ERCOT Independent Review of the Sharyland and BPUB Cross Valley Project

Version 1.0

Figure 9: Submitted Option

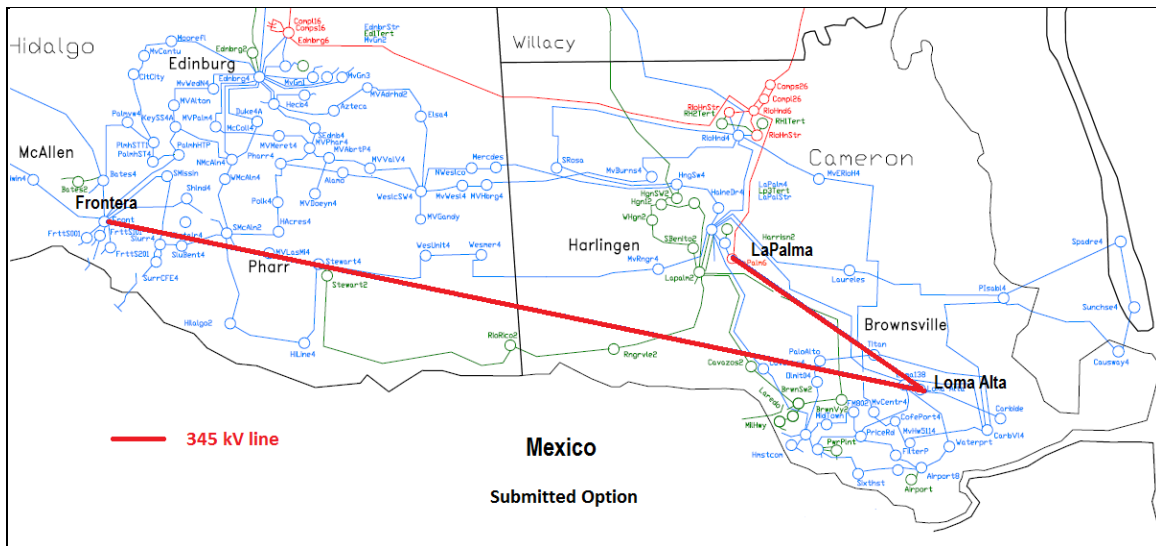
- Construct a new 345 kV bus at the Loma Alta station with two (2) 345/138kV autotransformers
- Construct a new 345 kV bus at the Frontera station with one 345/138 kV autotransformer
- Construct a new La Palma-Loma Alta 345 kV line (~14 miles) on new ROW using double circuit capable towers with one circuit in place
- Construct a new Frontera-Loma Alta 345 kV line (~59 miles) on new ROW using double circuit capable towers with one circuit in place

The cost estimate for the Submitted Option is estimated to be \$259.9M. Below are the contingency analysis results with the Submitted Option implemented in the study model:

N-1-1 Post-contingency overloads: (prior outage of the Rio Hondo-Ajo 345 kV line)

- Aderhold to Hidalgo Energy Center 138 kV line (125.6% of contingency rating)
- Elsa to Aderhold 138 kV line (117.6% of contingency rating)
- Weslaco Unit to Stewart Road 138 kV line (116.7 % of contingency rating)
- Azteca to Hidalgo Energy Center 138 kV line (110.0% of contingency rating)
- Frontera 345/138 kV transformer (109.7% of contingency rating)
- Weslaco Switching Station to Stewart 2 138 kV line (108.4% of contingency rating)
- Azteca to SE Edinburg 138 kV line (107.0% of contingency rating)
- Weslaco Switching Station to Weslaco 138 kV line (102.8% of contingency rating)
- Elsa to Weslaco 138 kV line (101.9% of contingency rating)

Approximately 216 MW of load would need to be shed in order to resolve the above overloads.

N-1-1 Post-contingency overloads: (prior outage of the La Palma-Rio Hondo 345 kV line)

- Rio Hondo – East Rio Hondo 138 kV line (149.6% of contingency rating)

- East Rio Hondo – Central Avenue Sub 138 kV line (141.8% of contingency rating)
- Harlingen to Oleander 138 kV line (135.7% of contingency rating)
- Haine Dr. to Oleander 138 kV line (107.3% of contingency rating)

Approximately 314 MW of load would need to be shed in order to resolve the above overloads.

Figure 14: Option 5

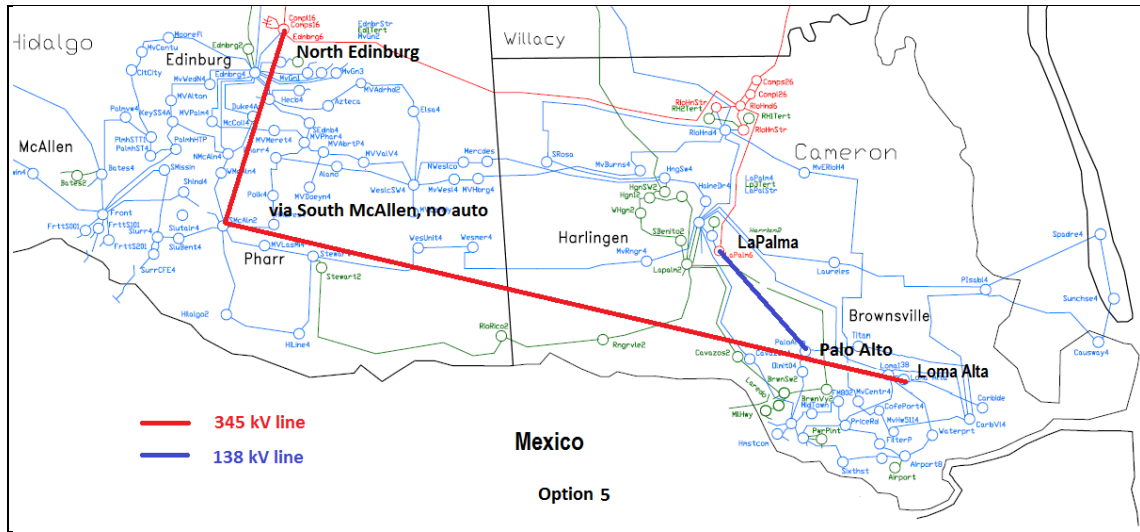
- Construct a new La Palma-Palo Alto 138 kV line (~12 miles) on new ROW with a rating of at least 215 MVA
- Construct a new North Edinburg-Loma Alta 345 kV line (double circuit capable with one circuit in place) routed in proximity to the existing South McAllen Substation (~106.5 miles) on new ROW
- Construct a new 345 kV bus at the Loma Alta station with one 345/138 kV autotransformer

The cost estimate for Option 5 is \$274.7M. Below are the contingency analysis results with Option 5 implemented in the study model:

N-1-1 Post-contingency overloads: (prior outage of the Rio Hondo-Ajo 345 kV line)

- Aderhold to Hidalgo Energy Center 138 kV line (107.8% of contingency rating)
- Weslaco Unit to Stewart Road 138 kV line (102.8 % of contingency rating)

Approximately 61 MW of load would need to be shed in order to resolve the above overloads.

N-1-1 Post-contingency overloads: (prior outage of the La Palma-Rio Hondo 345 kV line)

- Harlingen to Oleander 138 kV line (118.38% of contingency rating)
- Rio Hondo – East Rio Hondo 138 kV line (115.5% of contingency rating)
- East Rio Hondo – Central Avenue Sub 138 kV line (107.7% of contingency rating)

Approximately 135 MW of load would need to be shed in order to resolve the above overloads.

For these reasons ERCOT recommends that the facilities associated with Option 5 be constructed in order to meet the needs of the Brownsville area for 2016 and beyond. This recommendation is further supported by the fact that the North Edinburg to South McAllen 345 kV line portion of this project will be needed by 2020 and the South McAllen to east LRGV 345 kV line portion will most likely be needed sometime in the 2020s for N-1 contingency conditions. Hence, these facilities will meet both near-term and long-term needs for the entire LRGV. The following are the recommended transmission system improvements associated with Option 5:

It should be noted that ERCOT recommends that the Loma Alta 345/138 kV autotransformer be rated at least 600 MVA and the North Edinburg-Loma Alta 345 kV line have an emergency rating of at least 1600 MVA.
